**Project #22-021
Brickyard 2.0
Located at 800 N 50 W**

Project Name: Brickyard 2.0
Proponent / Owner: Jake Thompson / Direct Homes, Inc.
Project Address: 800 N 50 W
Request: Design Review Permit
Current Zoning: Mixed Use (MU)
Type of Action: Quasi-Judicial
Hearing Date: April 14, 2022
Submitted By: Tanya Rice, Planner II

Staff recommends that the Planning Commission **conditionally approve** a Design Review Permit for Project #22-021, Brickyard 2.0, in the Mixed Use (MU) zone located at 800 N 50 W, TIN #05-048-0018.

TITLE:
 1st floor plan

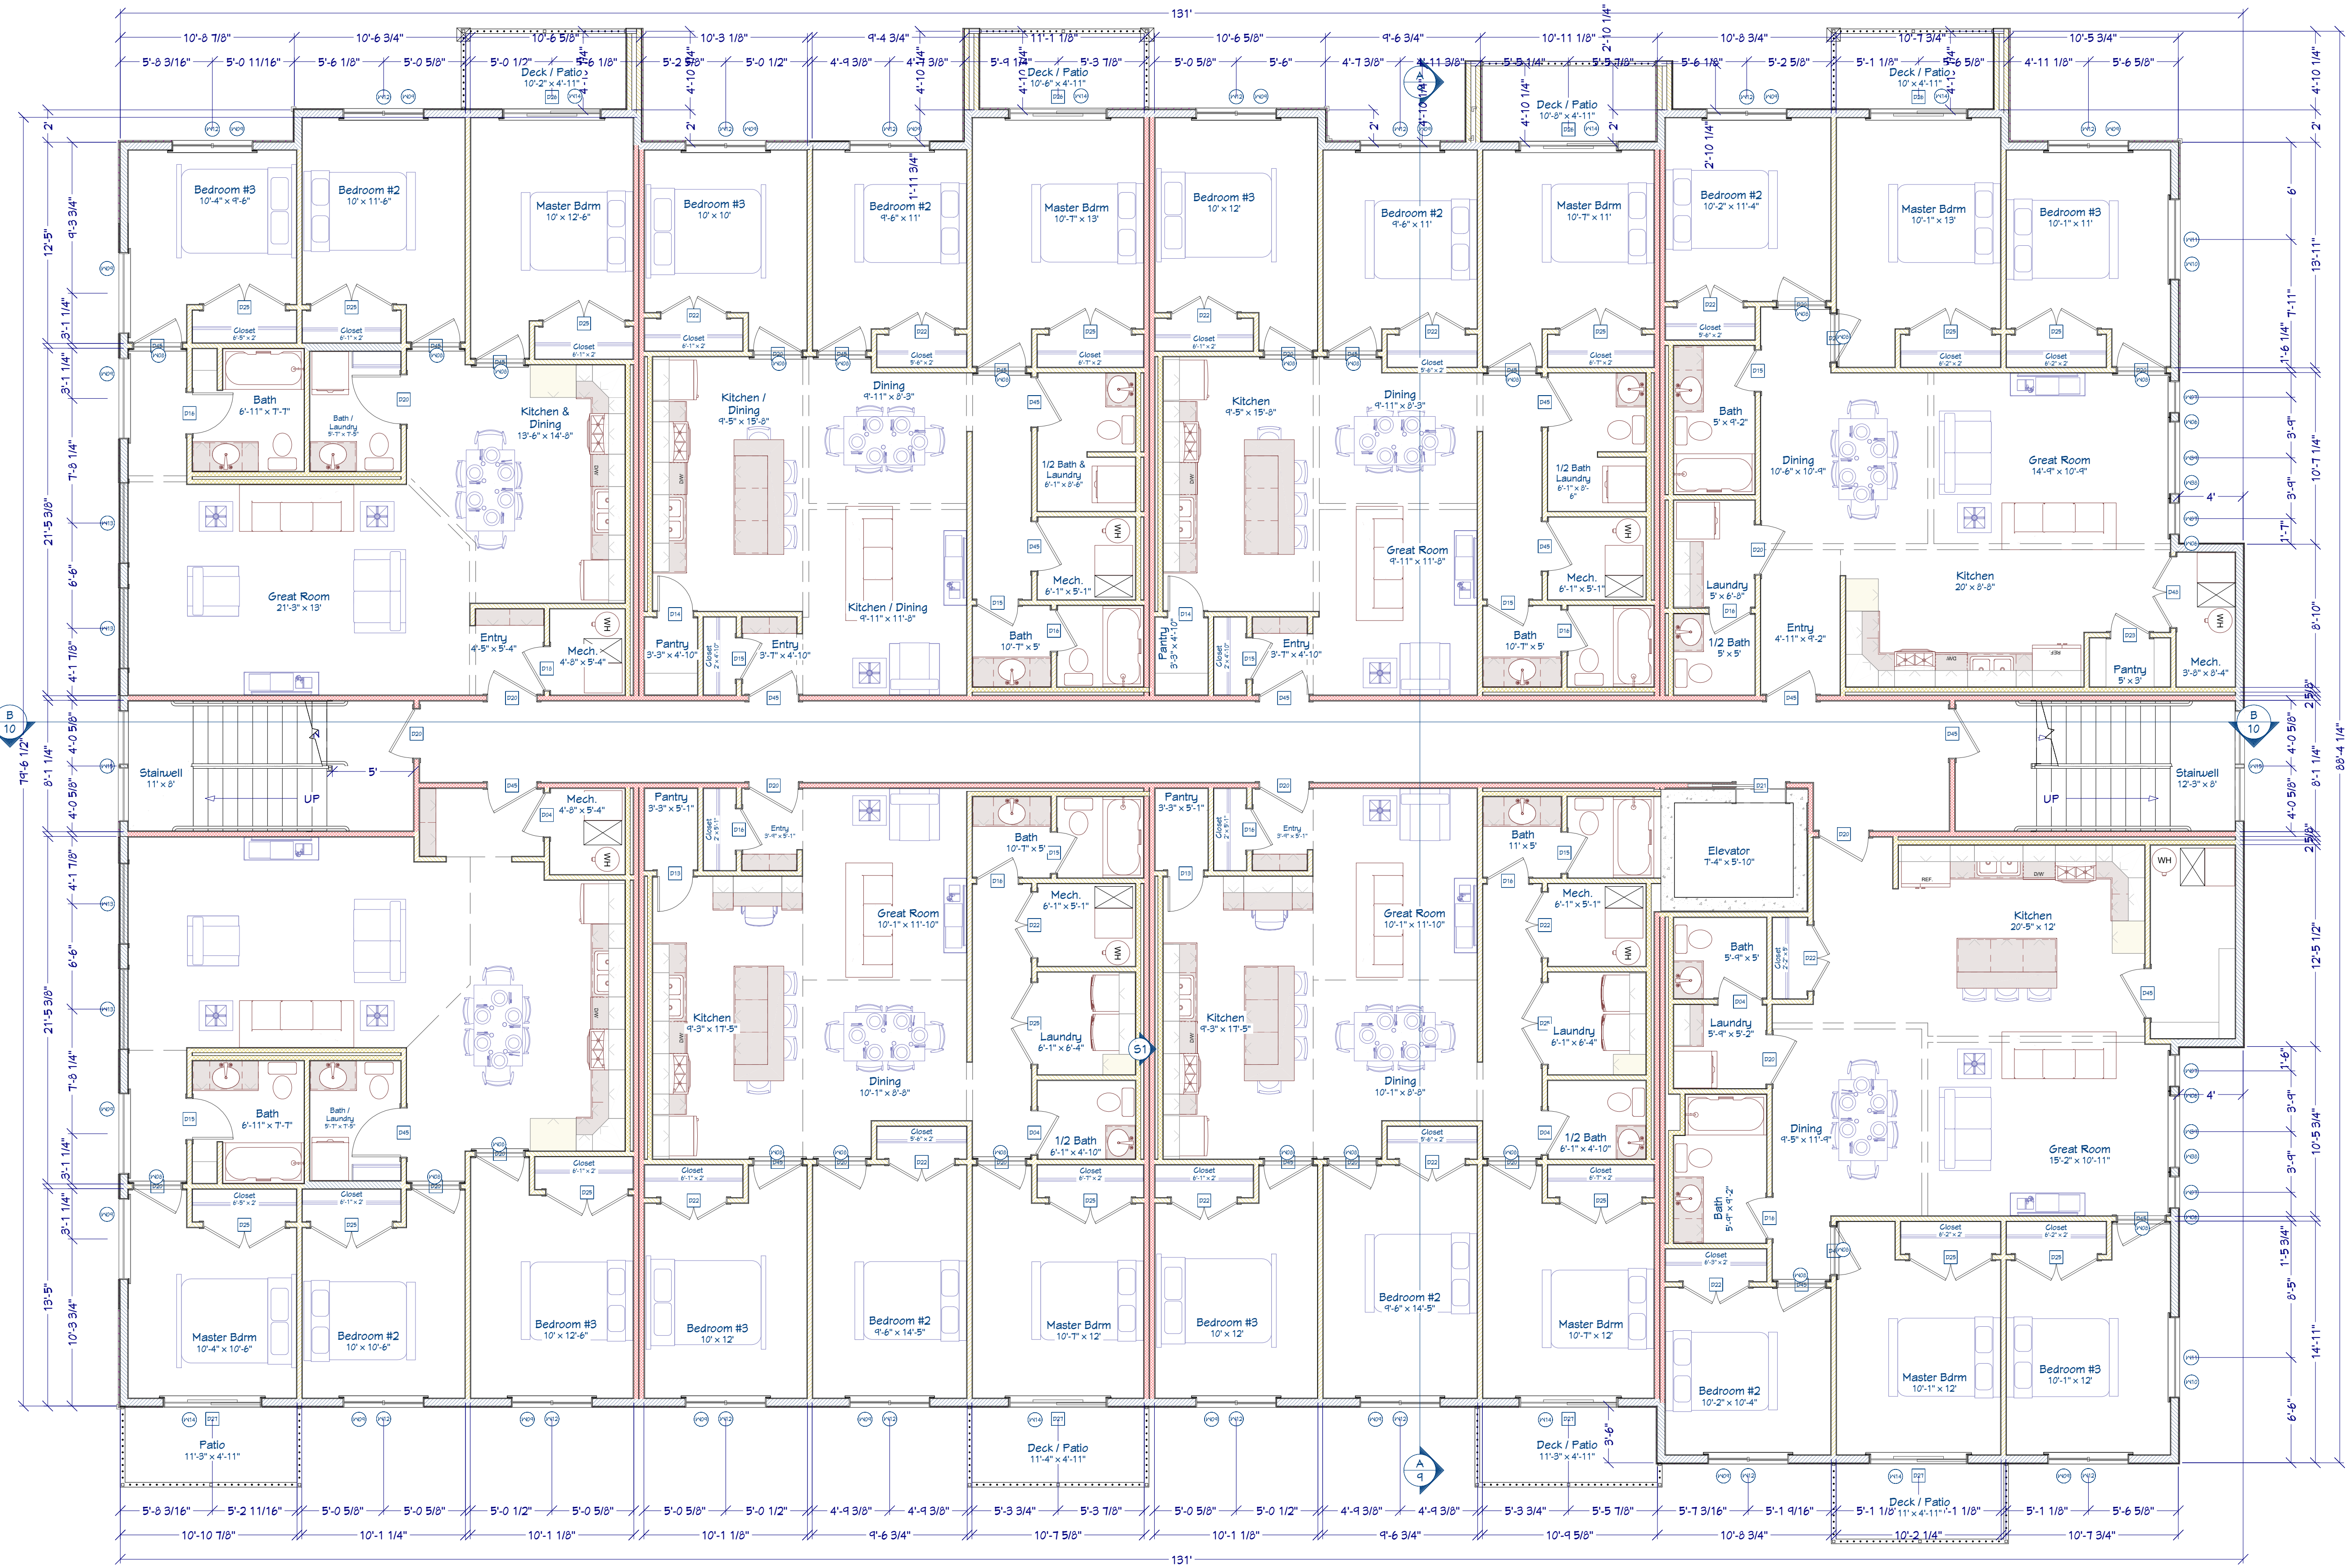
Is this the area you are concerned about?

check with Joe on if the riser room can be here.
